**PCN# 20140414001B
Design Revision (for Select TMP708/709 Devices)
Change Notification / Sample Request**

PCN Number:	20140414001B			PCN Date:	4/14/2014
Title:	Design Revision (for Select TMP708/709 Devices)				
Customer Contact:	PCN Manager	Phone:	+1(214)480-6037	Dept:	Quality Services
Proposed 1st Ship Date:	10/14/2014 7/14/2014		Estimated Sample Availability:	Date provided at sample request	
Change Type:					
<input checked="" type="checkbox"/> Design					
PCN Details					
Description of Change:					
<p>The purpose of Revision B is to correct the 1st Ship Date above. This PCN will expire on 7/14/2014 and the change may be implemented. We apologize for any confusion this may have caused.</p>					
<p>This notification is to inform of a design revision for select TMP708/709 devices. This design change does not affect the device's guaranteed datasheet specifications or electrical performance. The affected devices are listed in the "Product Affected" section.</p>					
<p>The table below describes changes that were made:</p>

Sample product shipping label to indicate die rev location (**not actual product label**)

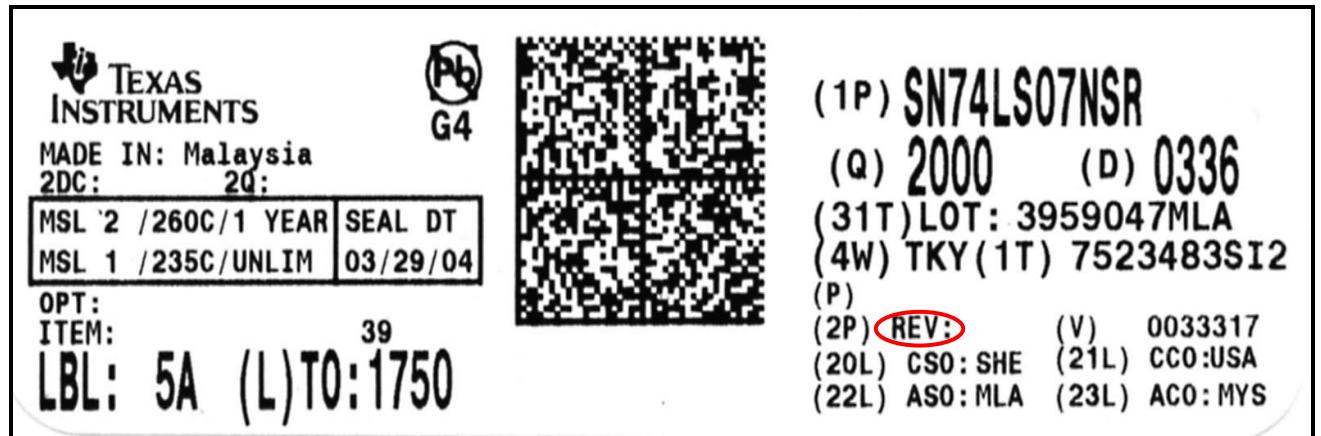
Die Rev designator will change as shown in table & sample label below:

Current	New
Die Rev [2P]	Die Rev [2P]
A	B
